<p>ISSUE:</p> <p>AS-BUILT</p> <p>27/09/2021</p> <p>AnchorSafe Projects</p>	<p>BY: DZ</p>	<p>APPROVED: DG</p>		<p>CLIENT:</p> <p>EXAMPLE AS-BUILT</p>	<p>TITLE:</p> <p>EXAMPLE AS-BUILT SITE INSPECTION & AUDIT OF EXISTING HEIGHT SAFETY SYSTEM SECTION 1</p>	<p>Quote No:</p> <p>-</p>
	<p>DRAWN: ANCHORSAFE</p>	<p>CHECKED:</p>		<p>SCALE:</p>		<p>Job No:</p> <p>-</p>
						<p>Quote No:</p> <p>-</p>

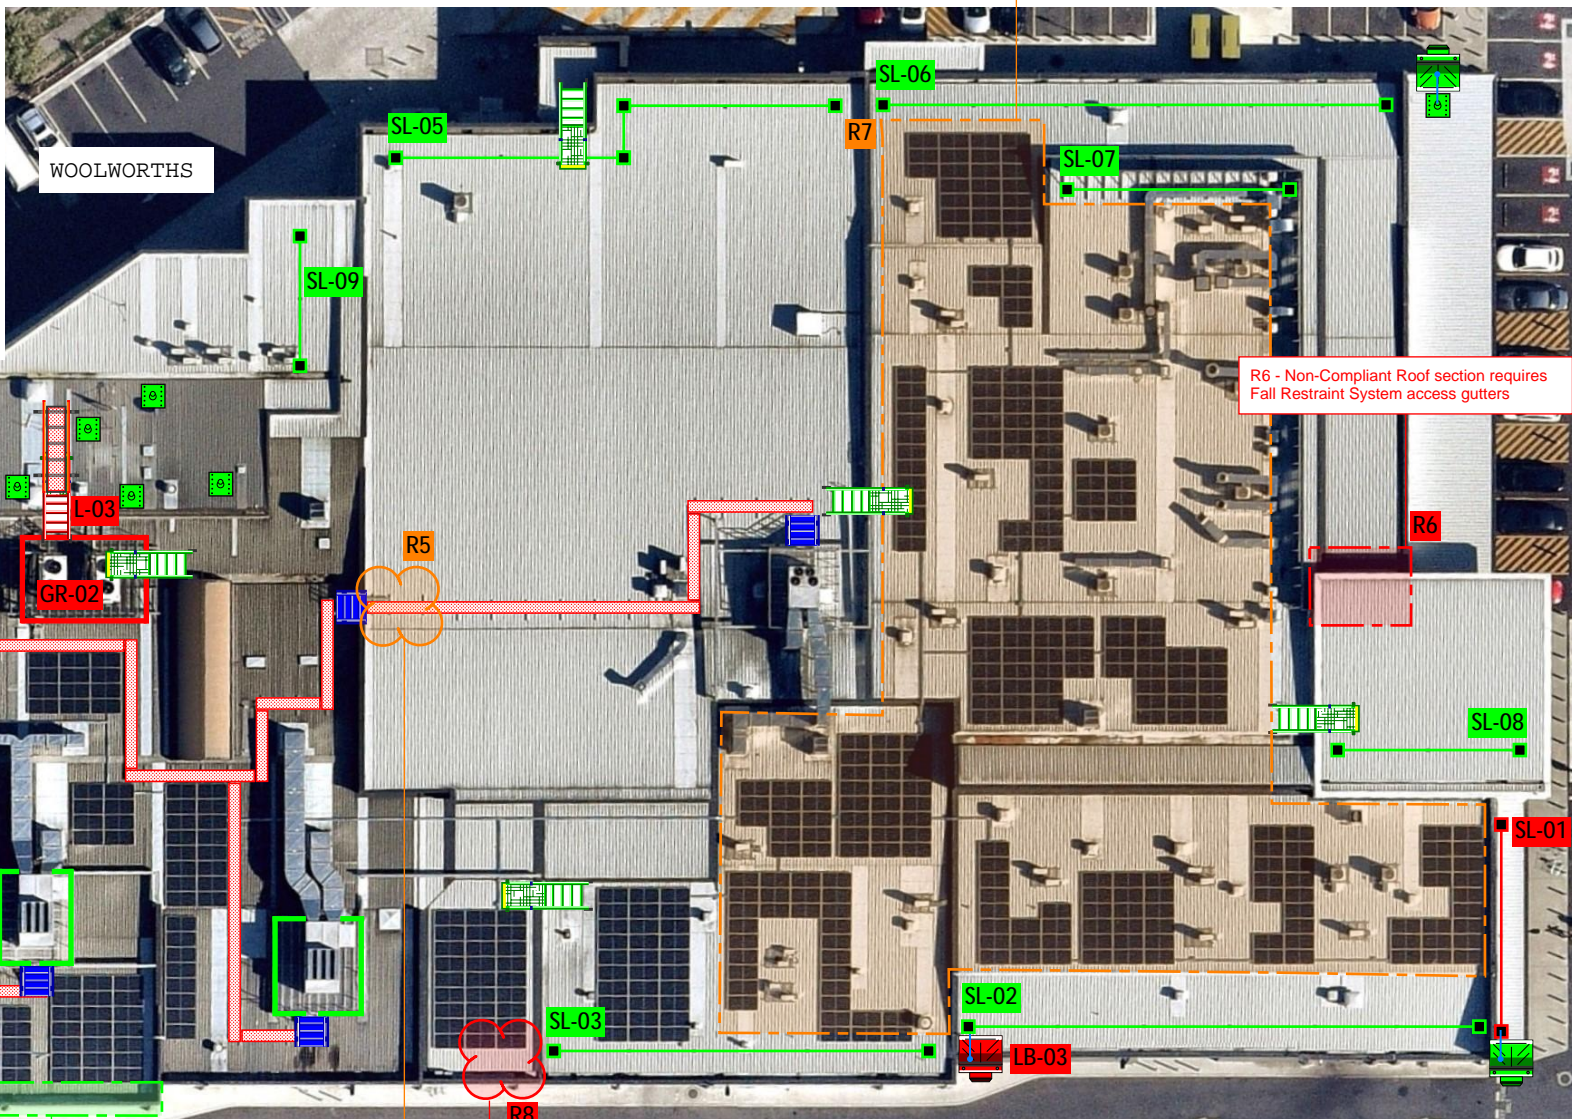
R7 - Walkway required to provide ease of access to all AC Units & Solar Panels requiring maintenance

R1 - Non-Compliant Roof Section requires Fall Restraint Access System

R6 - Non-Compliant Roof section requires Fall Restraint System access gutters

R2 - Non-Compliant Roof section requires additional Anchor Points to eliminate fall hazard

R3 - Parapet Crossover System required to provide Compliant Access, 1500x600mm

R4 - Parapet Crossover System required to provide Compliant Access, 1000x500mm

R5 - Guardrail to be at 2m in length at both sides of entry required for Compliant Access

R8 - Additional Anchor Point required for compliant access to Gutter
